BEAVER VALLEY POWER STATION, UNIT NO. 2

AMENDMENT TO FACILITY OPERATING LICENSE

Amendment No. 36
License No. NPF-73

ATTACHMENT TO LICENSE AMENDMENT NO. 36

FIGURE 3.4-2 BEAVER VALLEY UNIT 2 REACTOR COOLANT SYSTEM HEATUP LIMITATIONS APPLICABLE FOR THE FIRST 10 EPFY

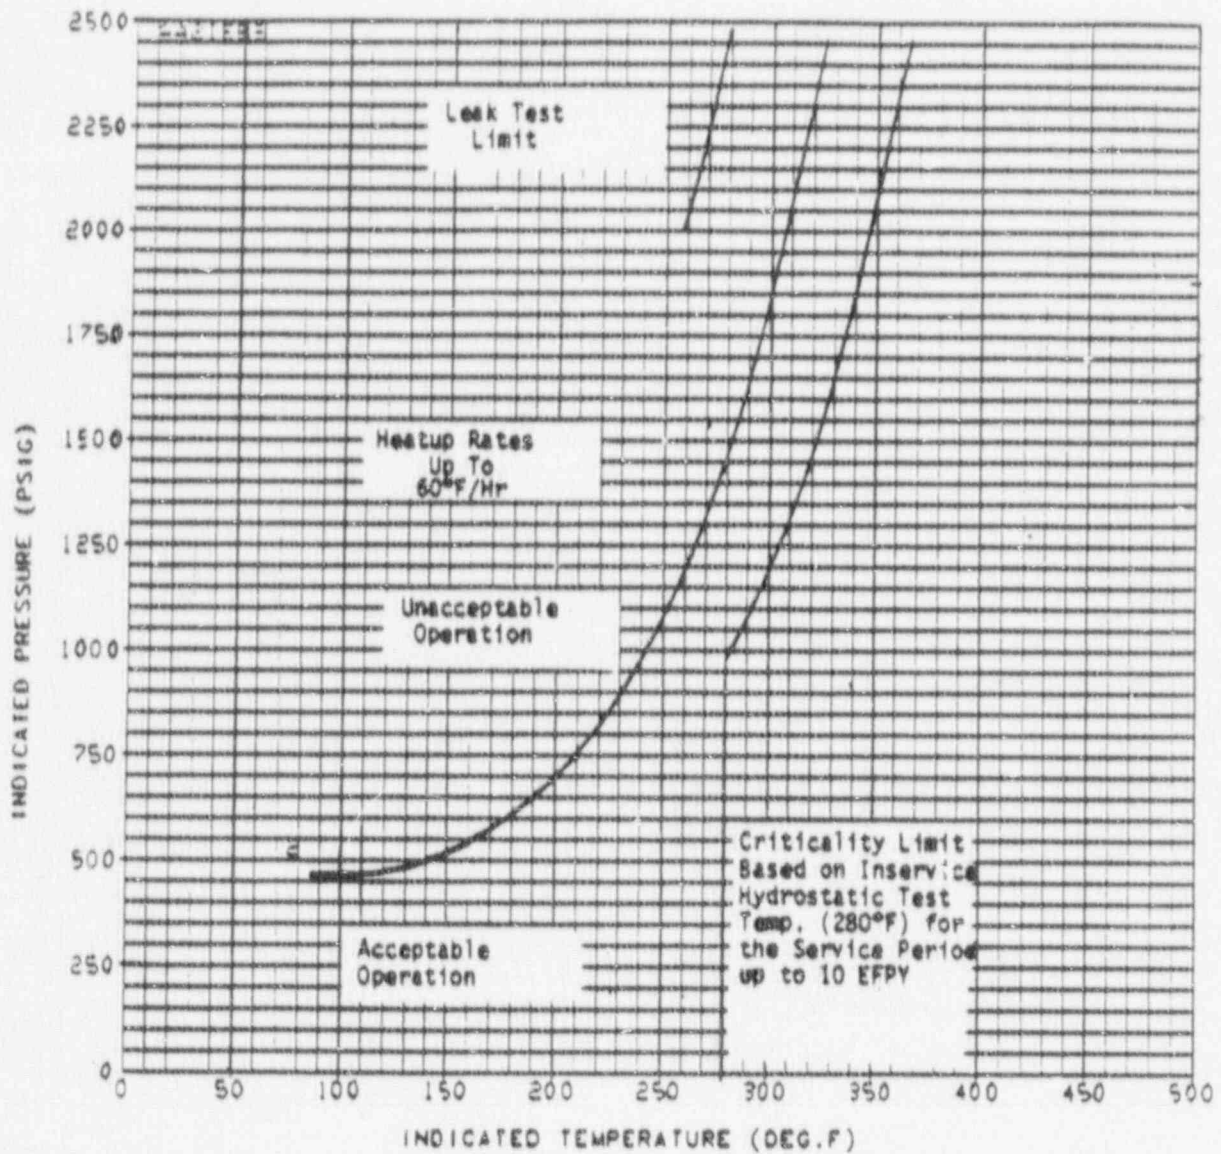
MATERIAL PROPERTY BASIS

CONTROLLING MATERIAL: INTERMEDIATE SHELL PLATE B9004-1

INITIAL RT_{NDT}: 60°F

RT_{NDT} AFTER 10 EPFY: 1/4T, 140°F

3/4T, 129°F

CURVES APPLICABLE FOR HEATUP RATES UP TO 60°F/HR FOR THE SERVICE PERIOD UP TO 10 EPFY. CONTAINS MARGIN OF 10°F AND 60 PSIG FOR POSSIBLE INSTRUMENT ERRORS.

FIGURE 3.4-3 BEAVER VALLEY UNIT NO. 2 REACTOR COOLANT SYSTEM
COOLDOWN LIMITATIONS APPLICABLE FOR THE FIRST 10 EPY

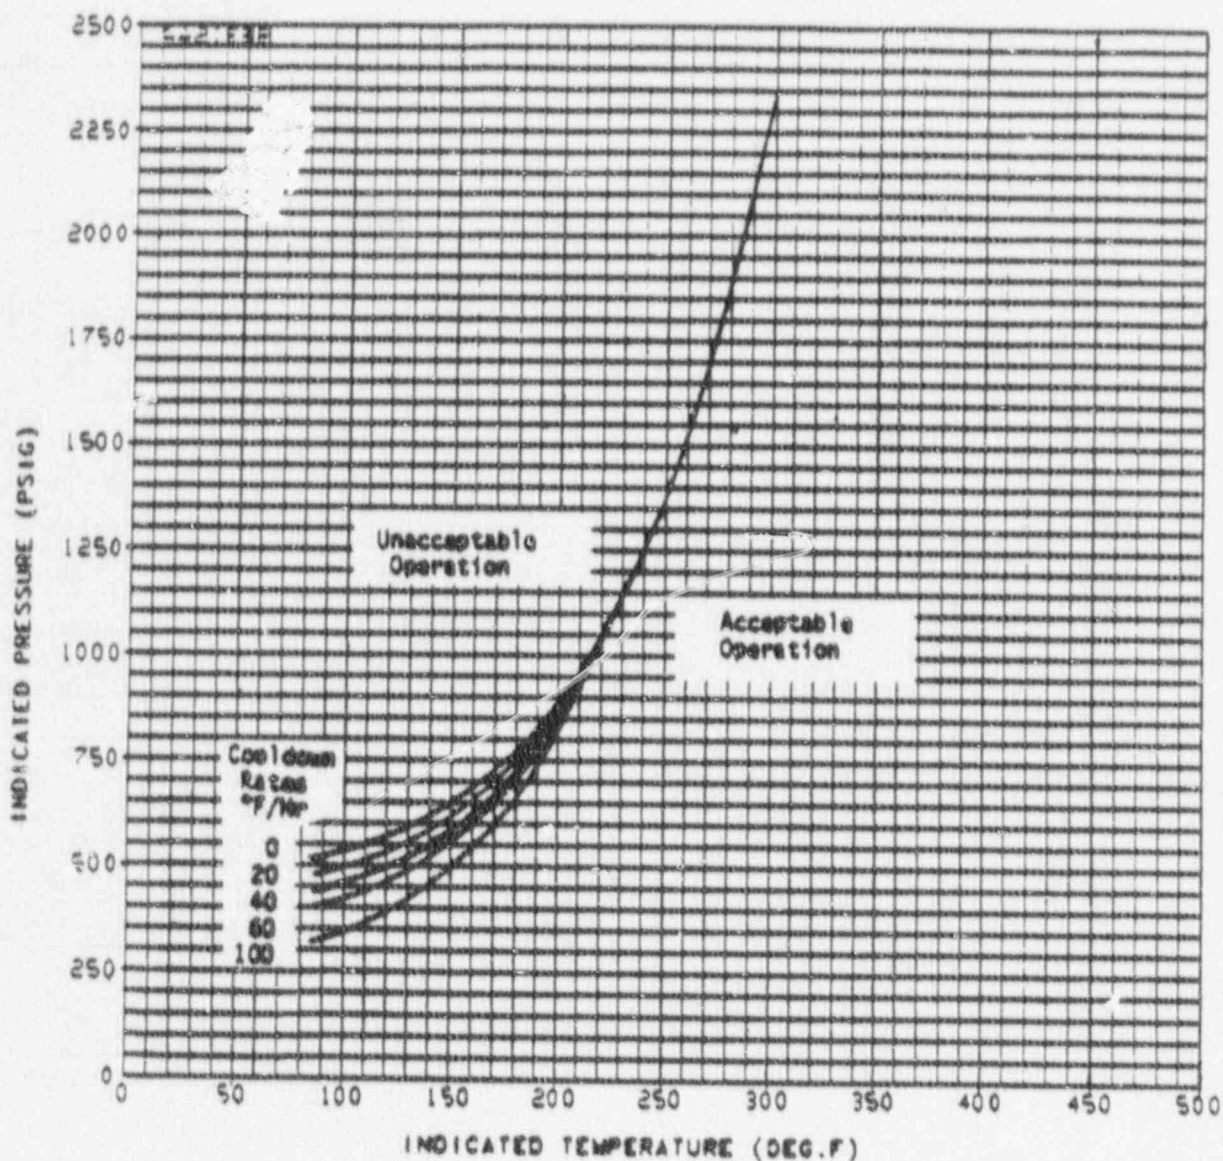
MATERIAL PROPERTY BASIS

CONTROLLING MATERIAL: INTERMEDIATE SHELL PLATE B9004-1

INITIAL RT_{NDT}: 60°F

RT_{NDT} AFTER 10 EPY: 1/4T, 140°F

3/4T, 129°F

CURVES APPLICABLE FOR COOLDOWN RATES UP TO 100 °F/HR FOR THE SERVICE PERIOD UP TO 10 EPY. CONTAINS MARGIN OF 10°F AND 60 PSIG FOR POSSIBLE INSTRUMENT ERRORS.
